Subject: EPA Comments on Alliant Energy, WI Power & Light Co -Nelson Dewey
Generating Station, Cassville, WI
Round 10 Draft Assessment Report

RE: Comment Request on Coal Ash Site Assessment Round 10 Draft Report - Alliant Energy Stations

**Re: Response to Draft Assessment Report
Nelson Dewey Generating Station**

Response
USEPA Draft Report
Safety of Coal Combustion Waste Ponds
Nelson Dewey Generating Station

Slag Pond Slope Stability Analyses Results Ten Most Critical Surfaces Per Analysis Nelson Dewey Generating Station

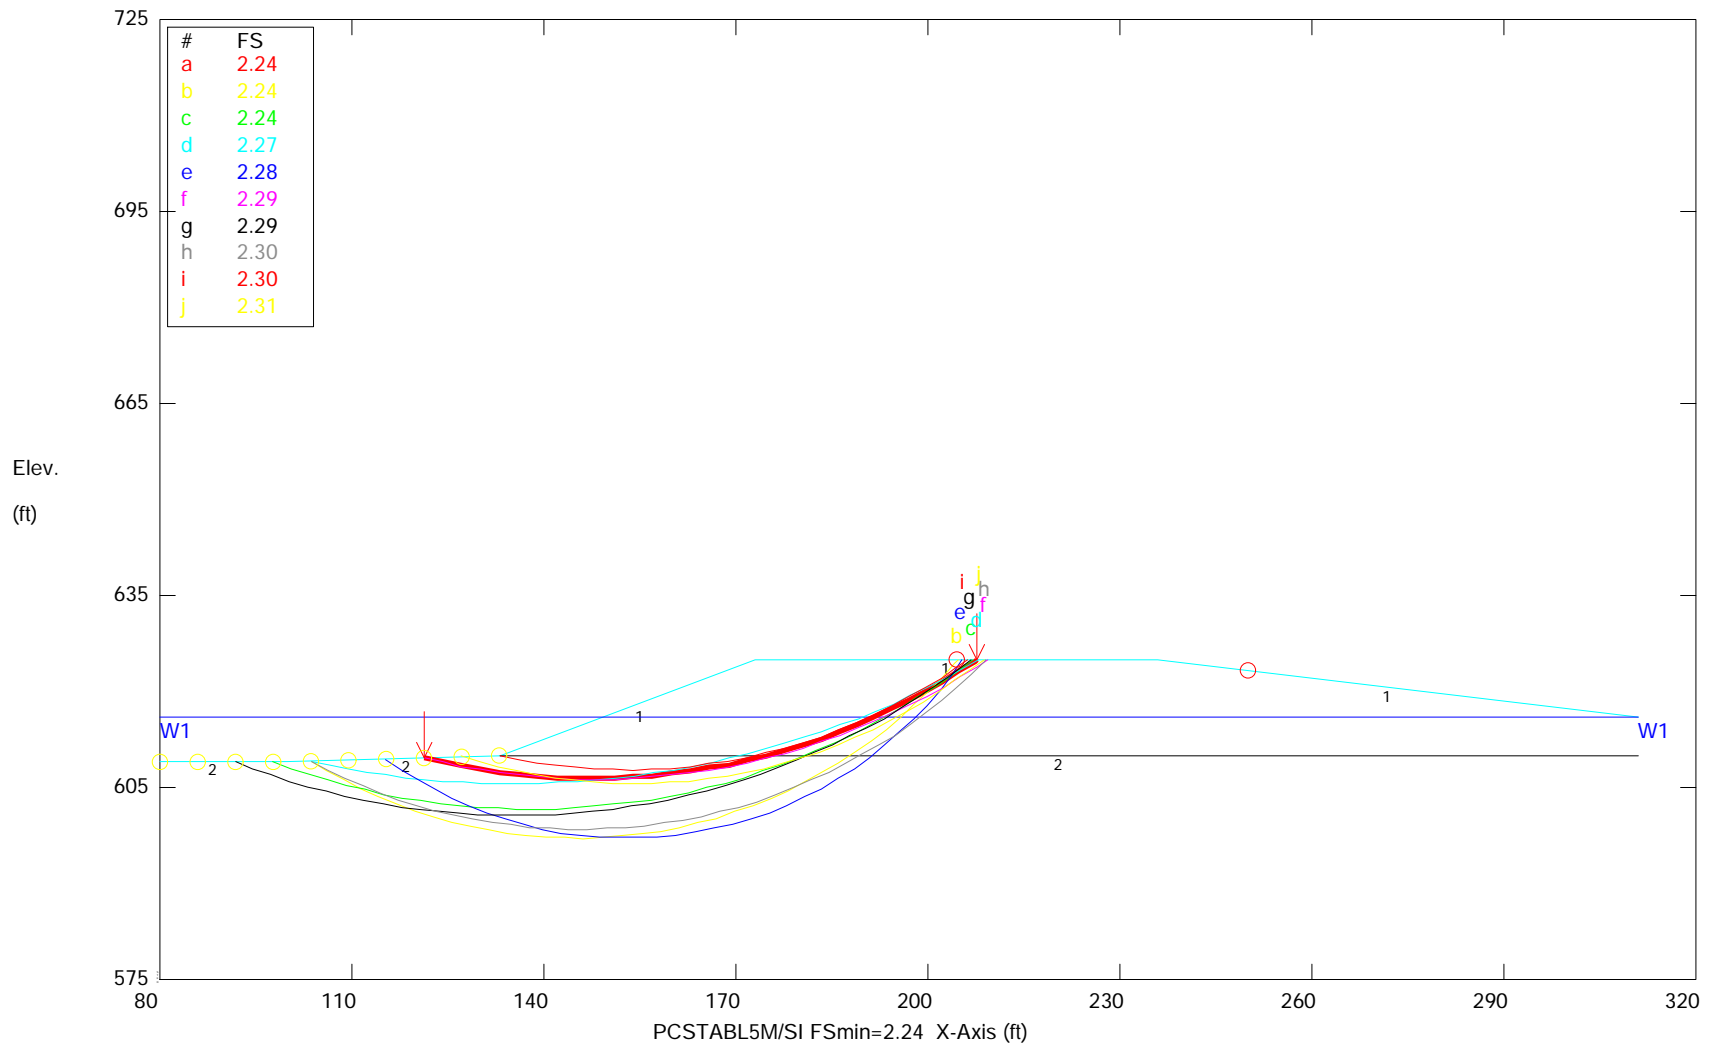
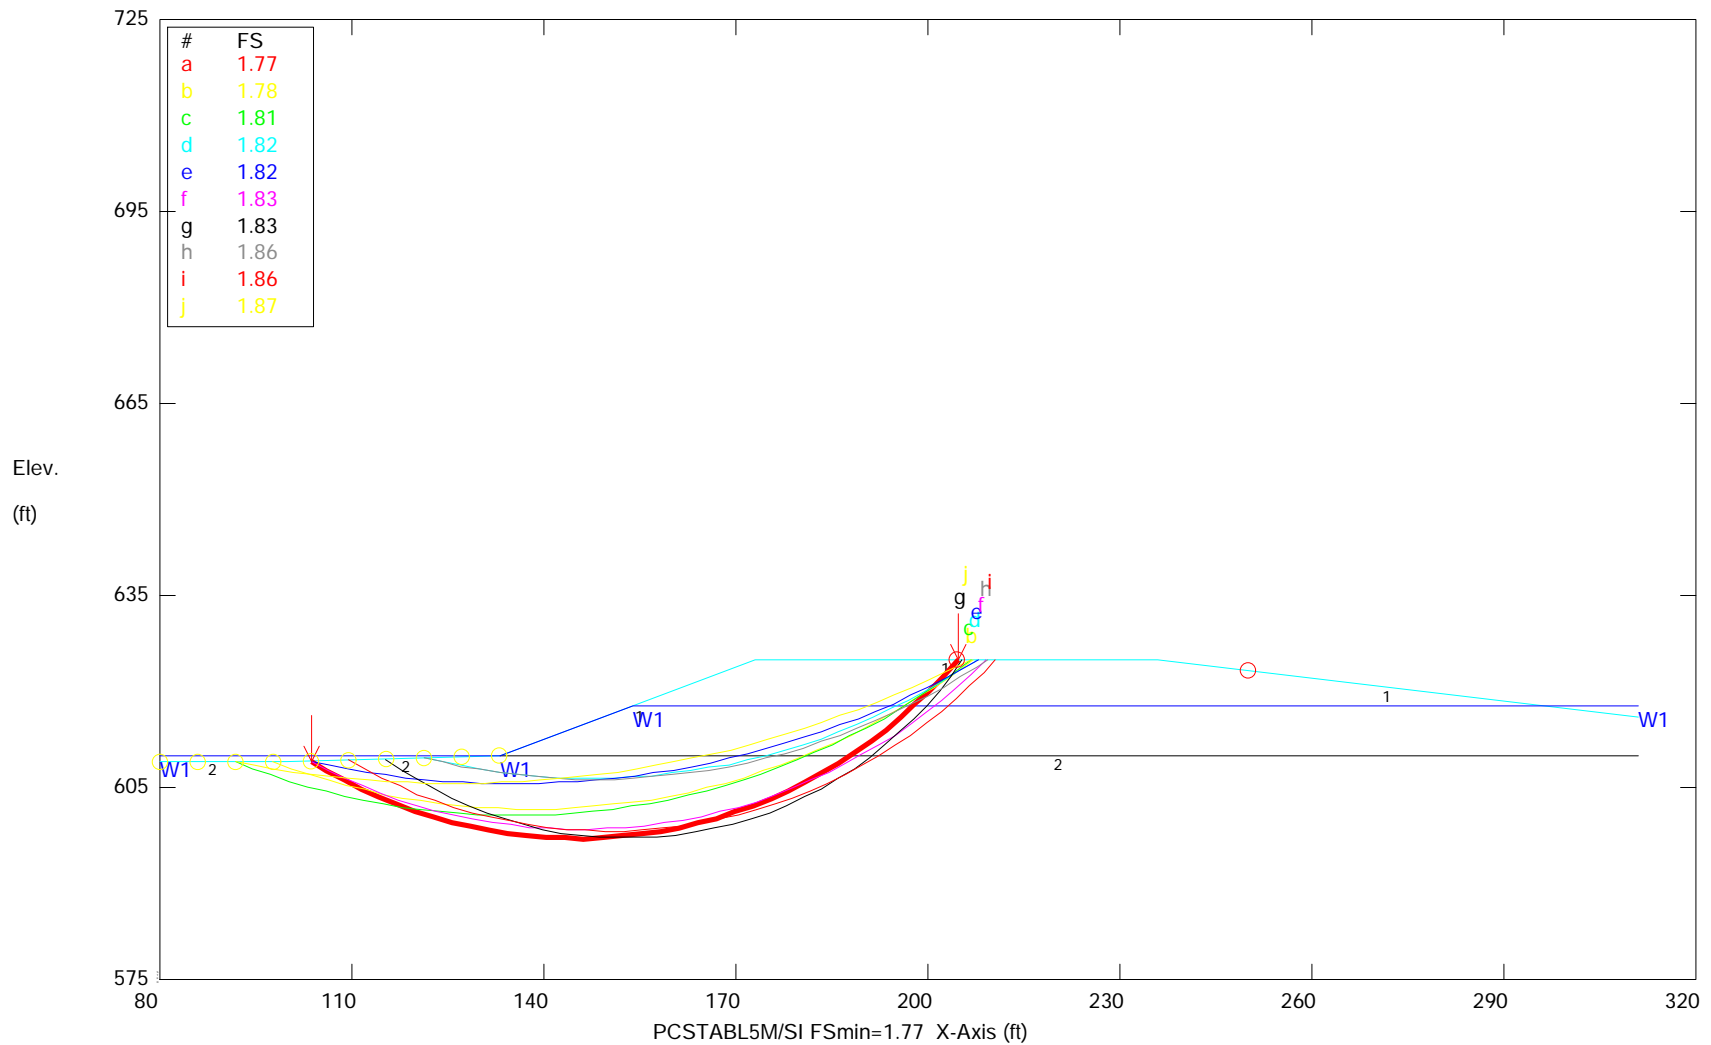
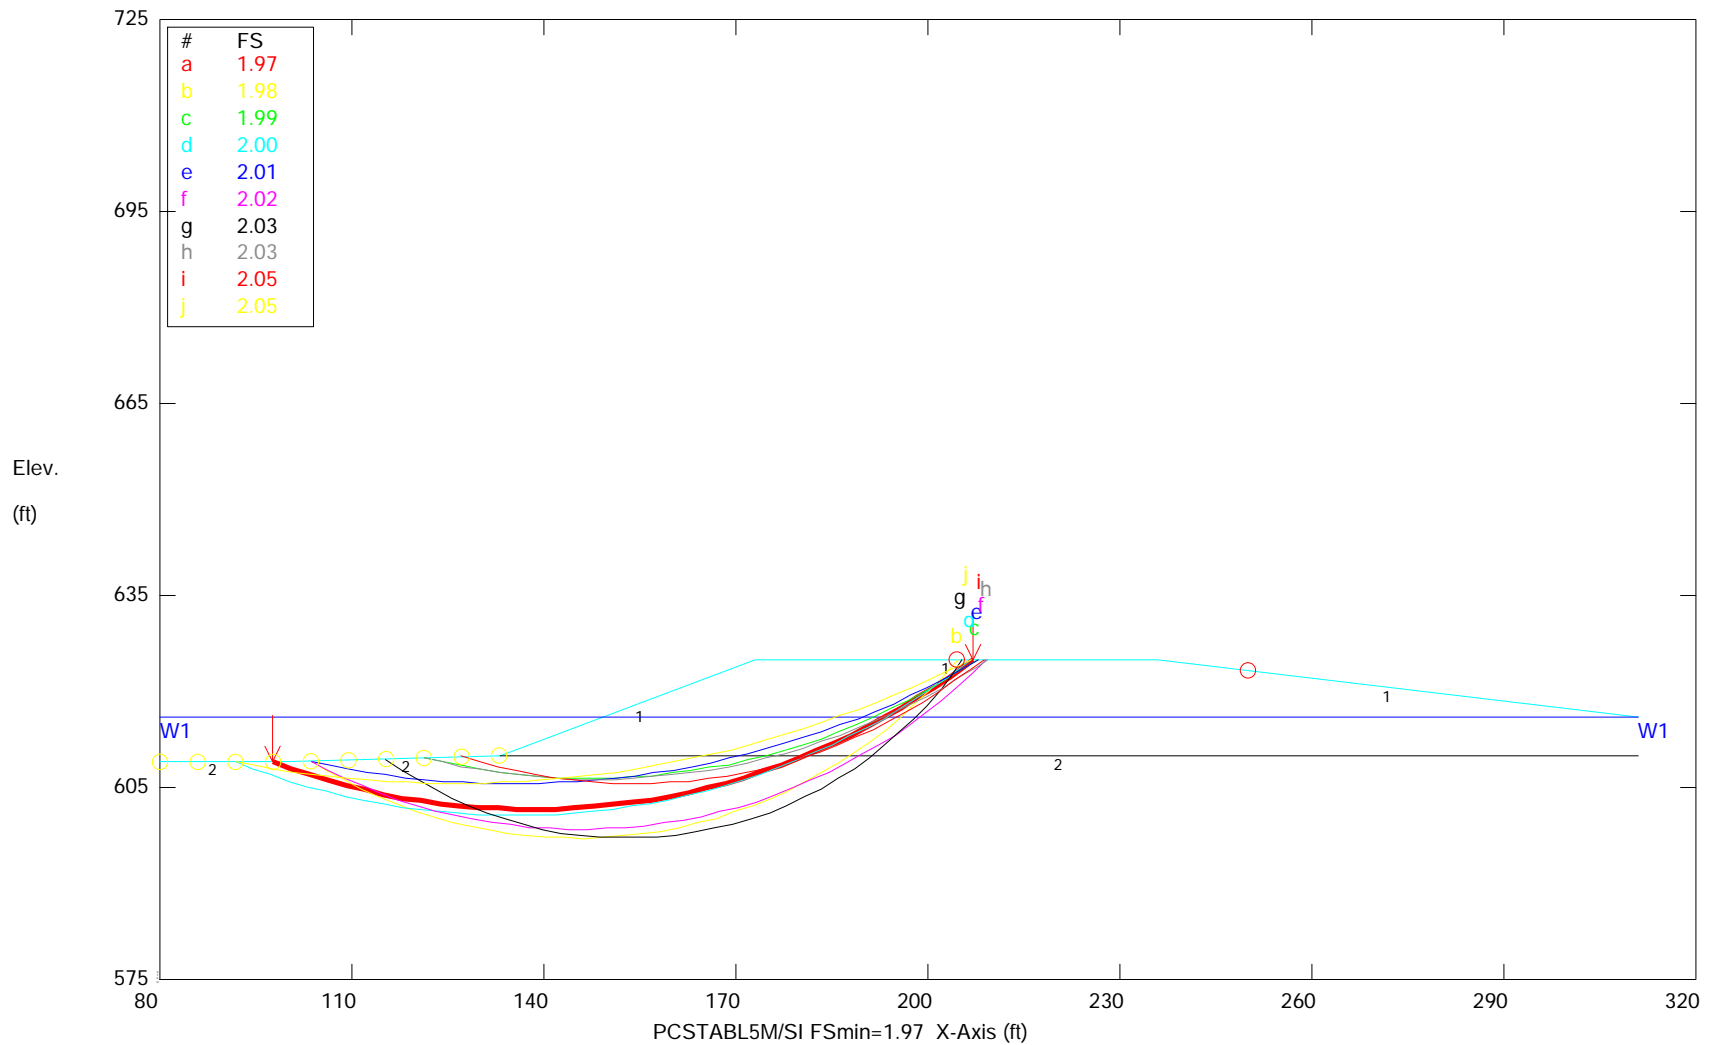
In addition to the adjustment of the soil strengths based on the URS 2007 borings, the Aether analysis¹ was also modified to show the static analysis of the WPDES Pond with water seeping vertically to the ground water surface approximately 10-feet below the normal highest operating water surface. For the Slag Pond, the static factor of safety was based on the potential failure of the inboard slope with the ground water elevation the same as the Slag Pond water elevation. For normal water levels, the WPDES Pond has a static slope stability factor of safety of 1.9, Attachment D, and the Slag Pond has a static factor of safety of 2.2, Attachment E.

For high water in the WPDES Pond (elevation 619.3 feet), the water surface at the toe of the embankment was assigned to the ground surface (elevation 614 feet) to maximize the seepage forces and cause the lowest factor of safety. Under this rapid loading condition combined with the new lower strength values the factor of safety is 1.4, Attachment D. Since this is similar to rapid drawdown the value is acceptable. For the Slag Pond, the high water condition is most analogous to rapid drawdown as the flow out of the pond to the Mississippi river would be rapid as the river stage lowers after a 100-year return flow. For rapid drawdown from the 100-year flood elevation to the bottom of the pond, the factor of safety is 1.8, Attachment E.

Finally, a new analysis of each pond with normal water elevation and the design earthquake as a pseudostatic load shows a factor of safety of 1.7 and 2.0 for the WPDES and Slag Ponds, respectively (Attachment D & E).
